## Board of Architectural Review

DATE: May 6, 2020  
TO: Board of Architectural Review Chair and Members  
THROUGH: Jason Sutphin, Community Development Division Chief  
FROM: Tommy Scibilia, BAR Liaison  
SUBJECT: **EYA Townhouses**

1. Case Number:	BAR-20-00113
2. Address:	3500 Pickett Road
3. Tax Map Parcels	58 1 02 021
4. Request:	50 townhouses and site improvements
5. Applicant:	EYA Development LLC
6. Applicant's Representative:	Aakash Thakkar
7. Status of Representative:	Agent
8. Current Zoning:	RL Residential Low
9. Proposed Zoning:	PD-R Planned Development Residential

ARCHITECTURAL ELEVATIONS

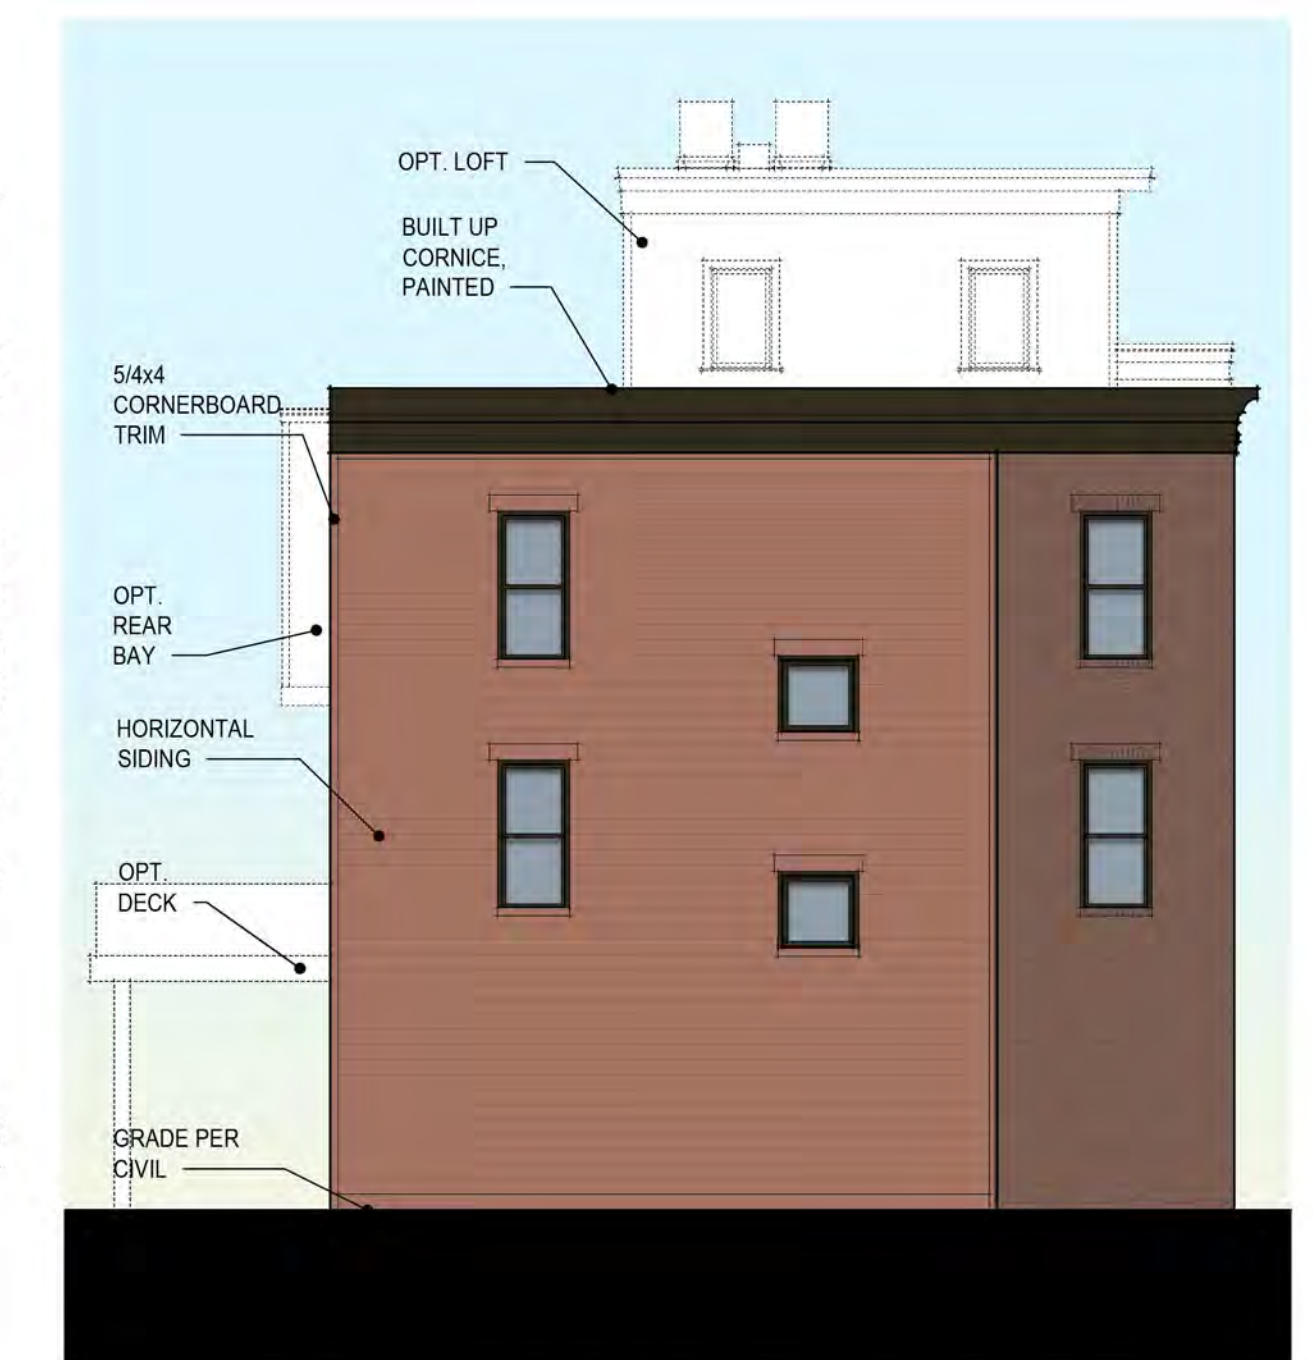
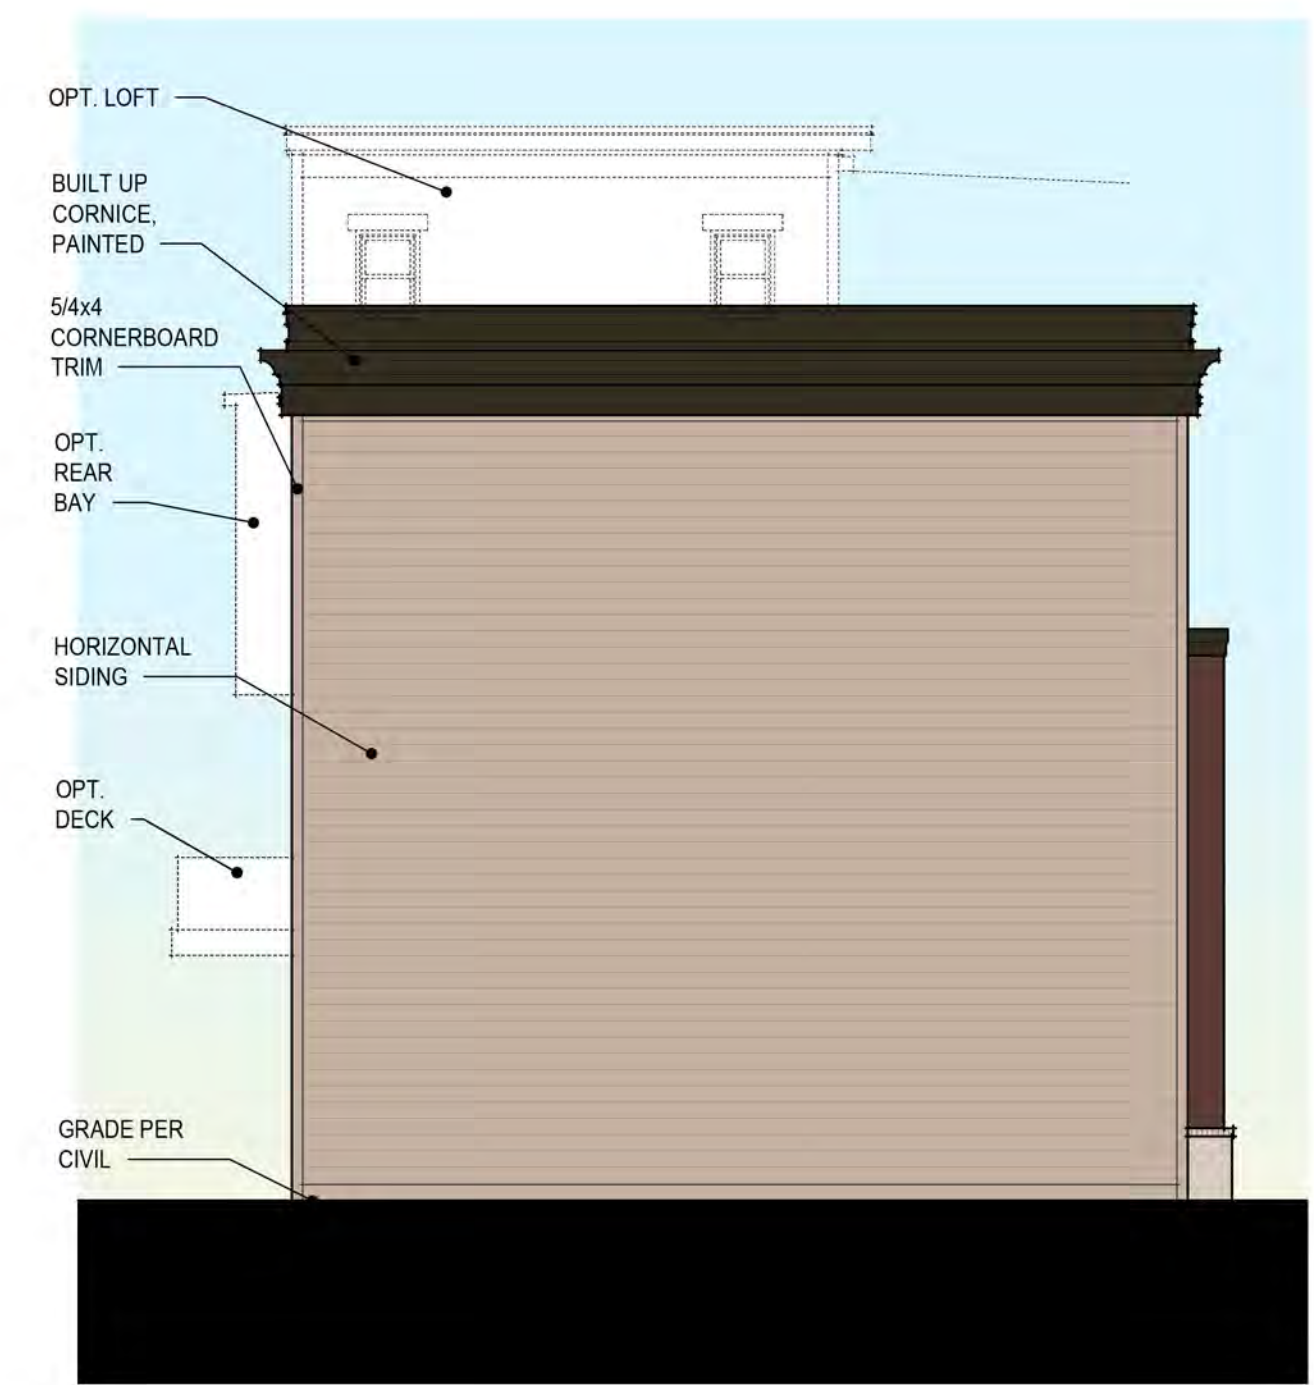
The elevations show the use of cementitious products down to the ground plane in some areas. Staff believes that a masonry material with a brick veneer should be used at the foundation level on all sides of all townhouse units, for both an enhanced aesthetic, and for protection of less durable fiber cement products. See recommendation below.

Staff is concerned that the lack of variation in unit setback within townhouse sticks will result in a flat appearance, not consistent with the intent of the above guidelines or with the Zoning Ordinance, which requires varied setbacks (see §3.5.1.C in Attachment 1). The applicant is requesting a modification to this Zoning requirement as part of their land use application, but staff believes that the building articulation would be enhanced if the setbacks were varied. Staff also believes a variation in setbacks for

TYP. FOUNDATION LANDSCAPE PLAN -  
FRONT LOAD UNITS

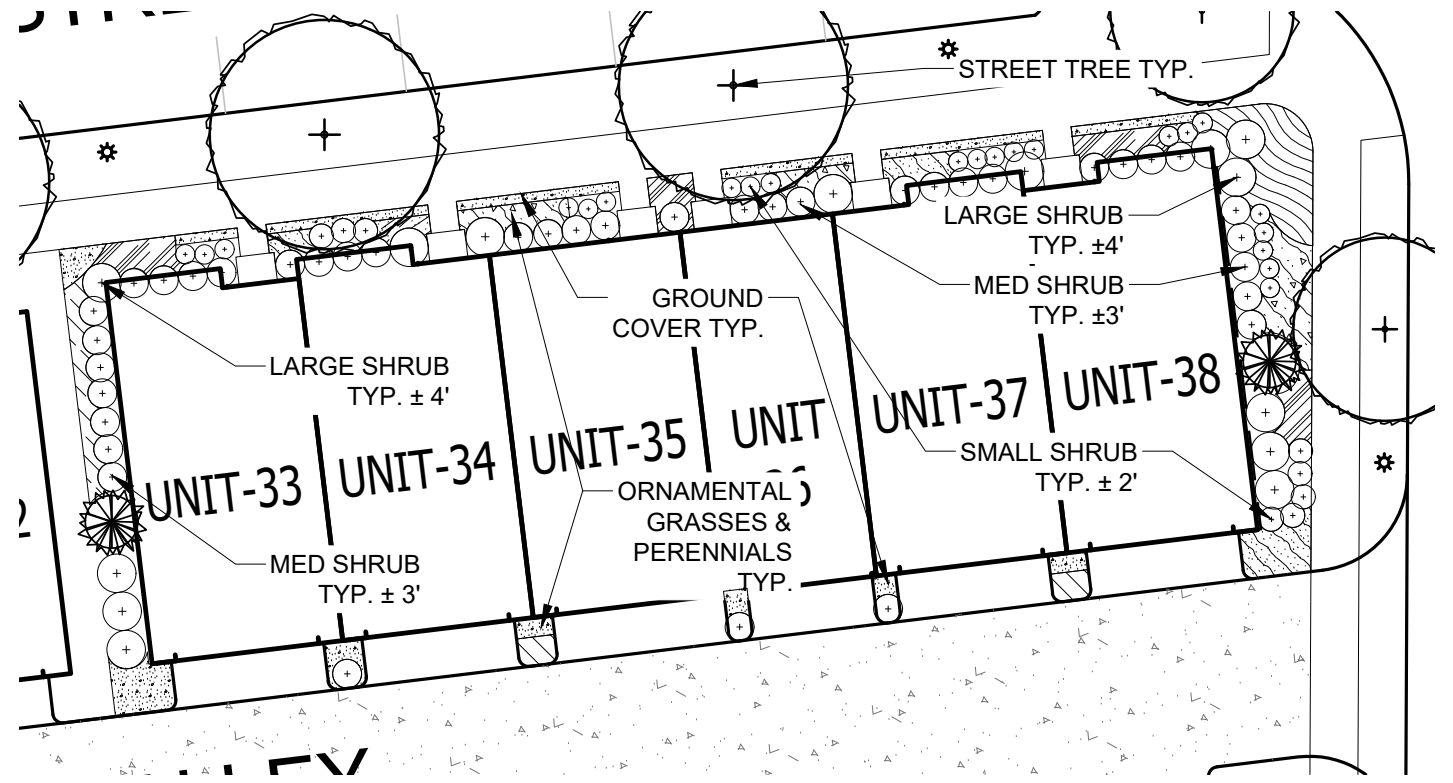
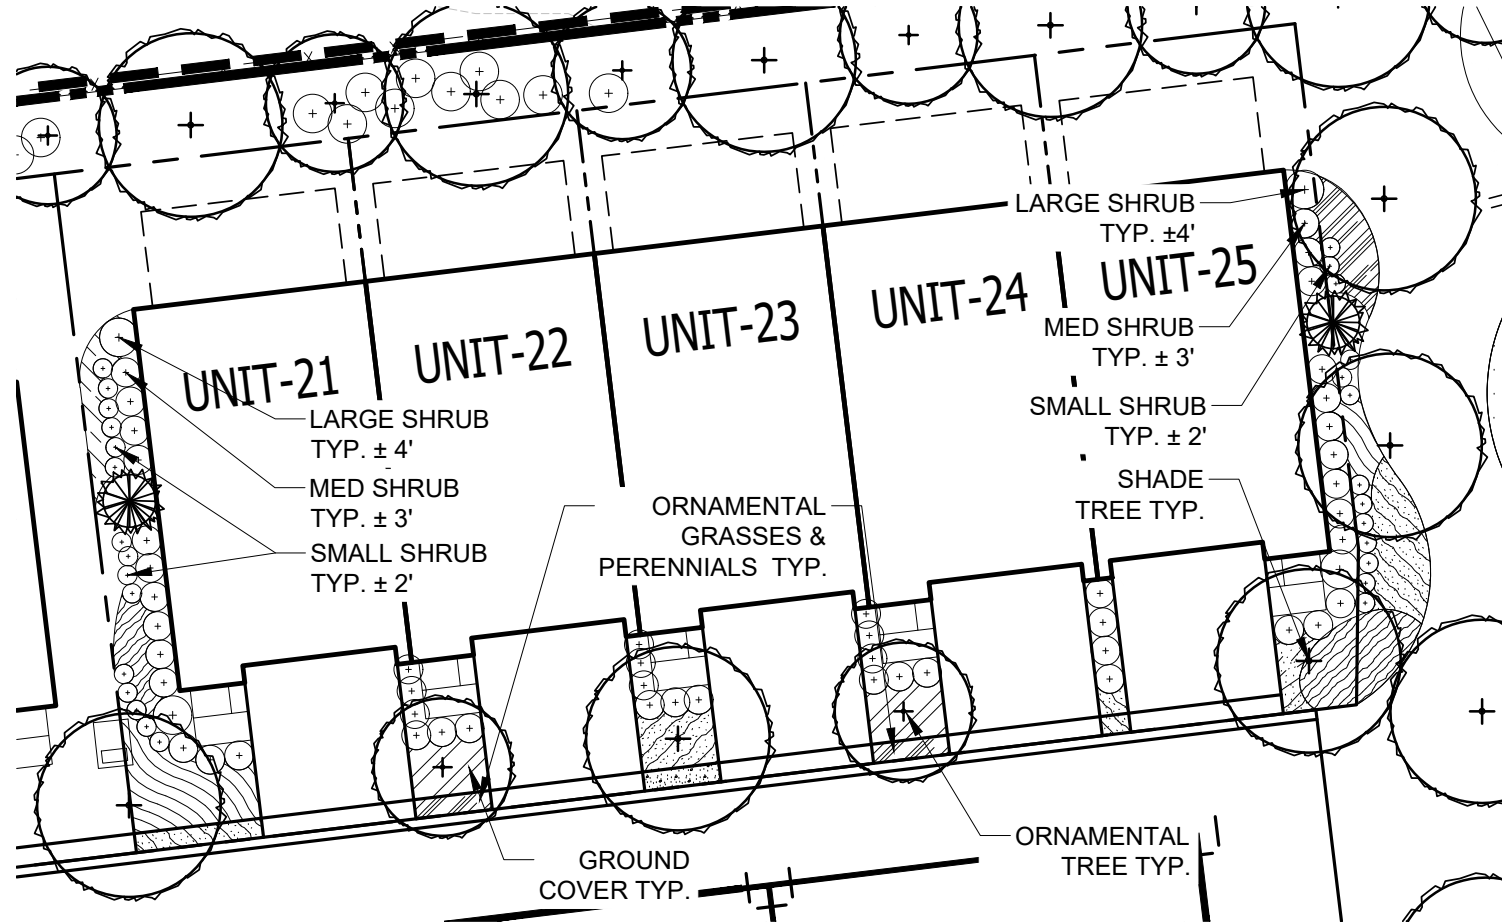
Typical yard landscaping for both the rear- and front-loaded townhouse units can be found on sheet L5 of Attachment 4. The rear-loaded units would have shallow front yards planted with shrubs, perennials, and decorative glasses. A single shrub or ground cover would be planted in the narrow spaces between the driveways of these units. The front-loaded units would have more space between their driveways and in front of their stoops for a small landscaped yard with shrubs, groundcover, ornamental grasses, and one small canopy tree or ornamental tree. The side yards of both unit types would have more substantial plantings with a variety of different-sized shrubs, groundcover, and ornamental grasses. A variety of species would be used for yard plantings, which are listed on the tables on sheet L6 of Attachment 4.

**1 TRANSFORMER SCREEN SECTION SECTION**  
 Scale: 3/8" = 1'-0"

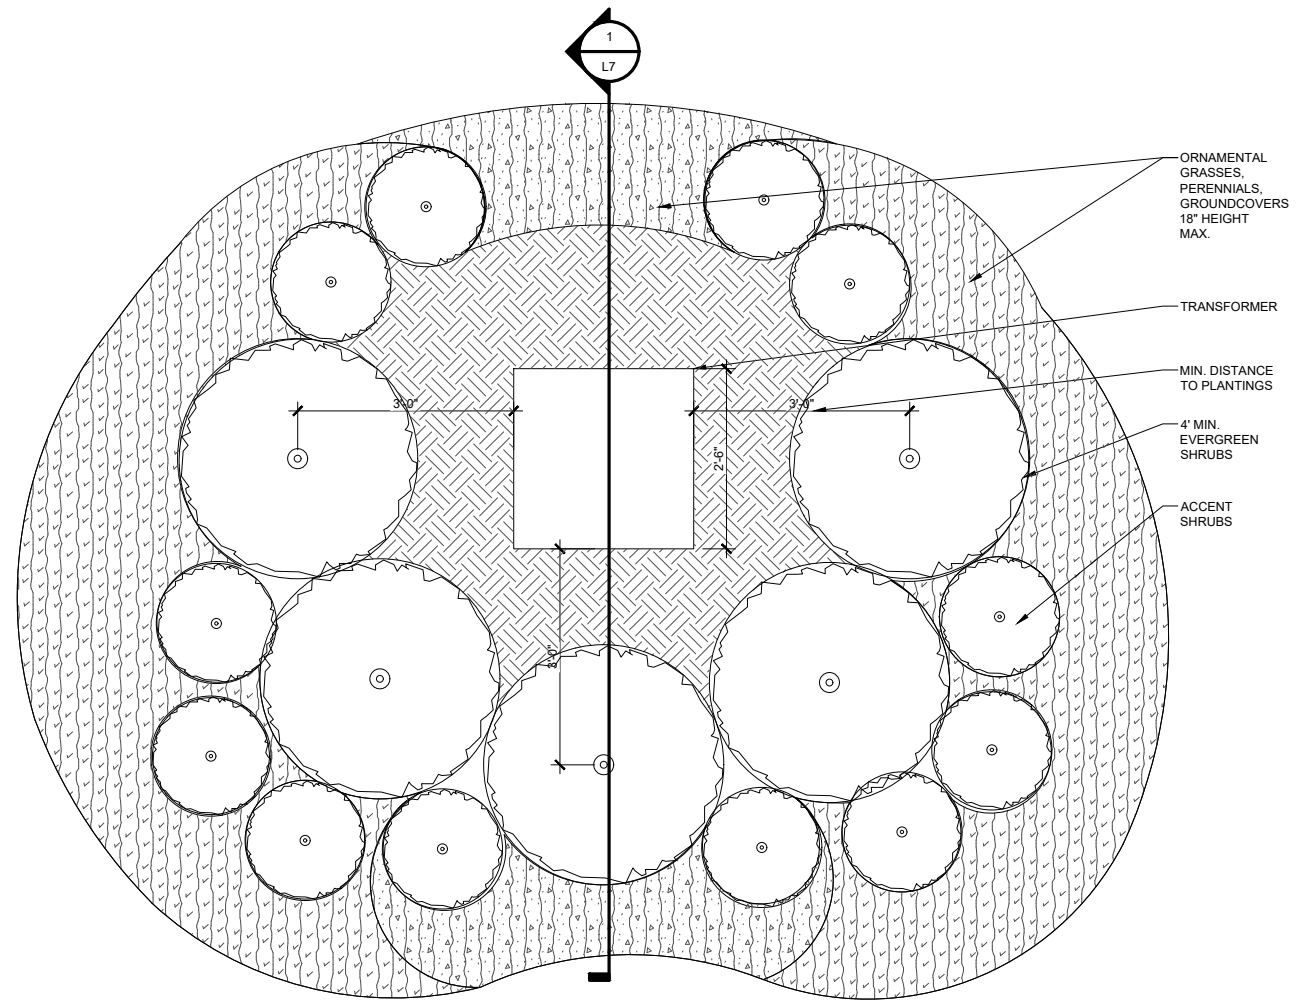
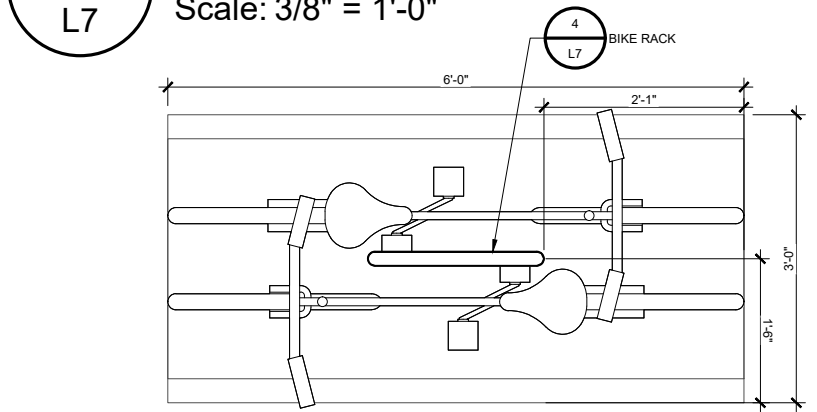
vehicle turnaround area of the western portion of the loop road. The applicant has provided a planting detail on sheet L7 of Attachment 4 that shows how these would be screened with four-foot-tall evergreen shrubs, smaller accent shrubs, and decorative grasses surrounding the units.

**1** PRIVACY FENCE SECTION A  
L8 Scale: 3/8" = 1'-0"

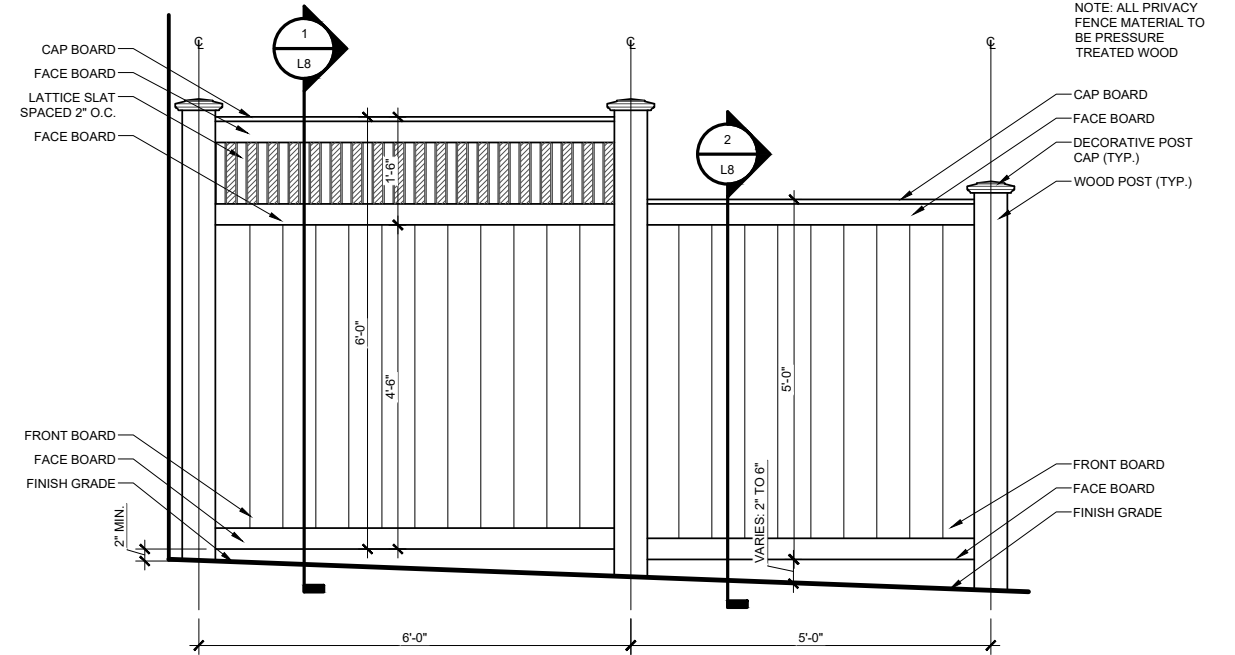
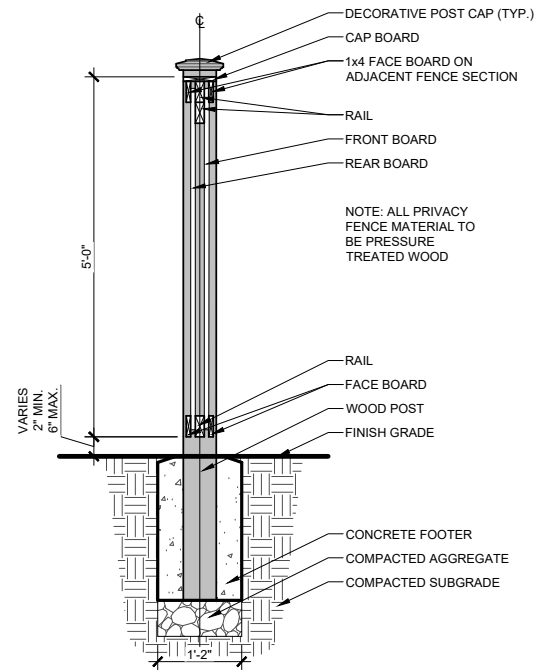
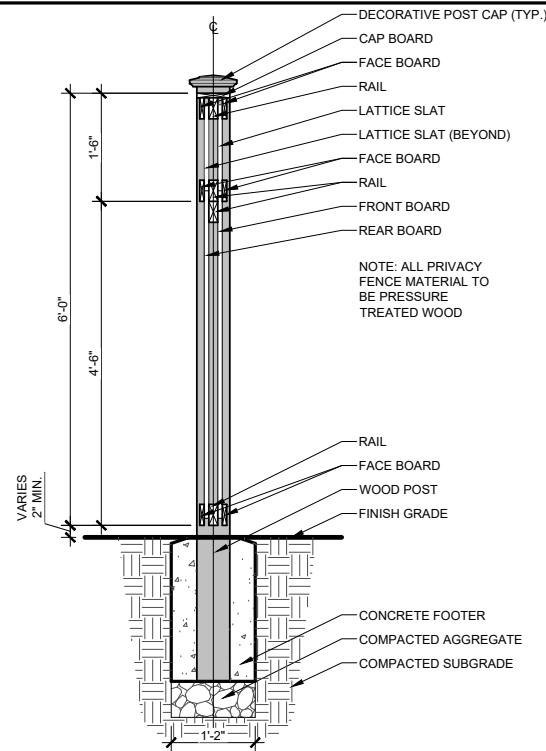
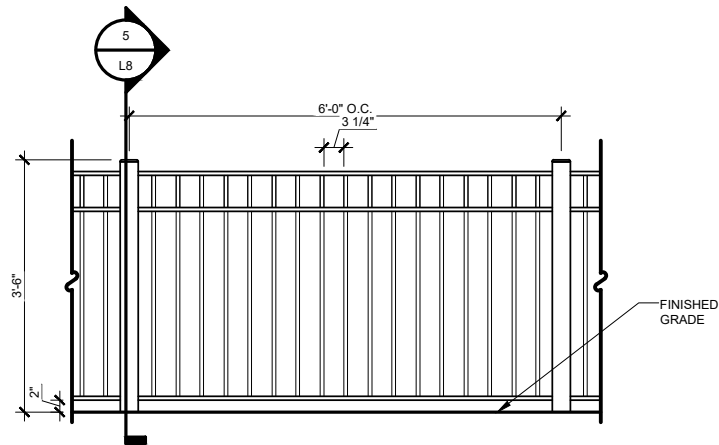
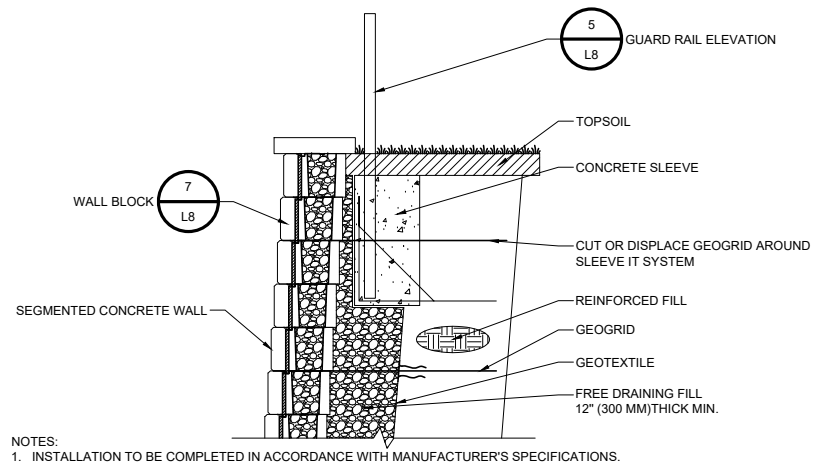
Staff finds the use of gray split-face CMU for the retaining walls with decorative black metal railing along the tops, as well as the use of individual board-on-board wood fencing for privacy between individual rear yards for the front-loaded units to be consistent with the above guidelines. In concurrence with a comment made at the Planning Commission work session for this project held on April 27, 2020, staff believes that a six-foot-tall board-on-board wooden privacy fence should be used across the top of the south retaining wall instead of the decorative railing proposed. The City plans to construct a trail through this forested land that would be located in close proximity to the shared border with the subject site, and staff believes that a board-on-board fence would create needed privacy for the rear yards of the south stick of townhouses. See recommendation below.
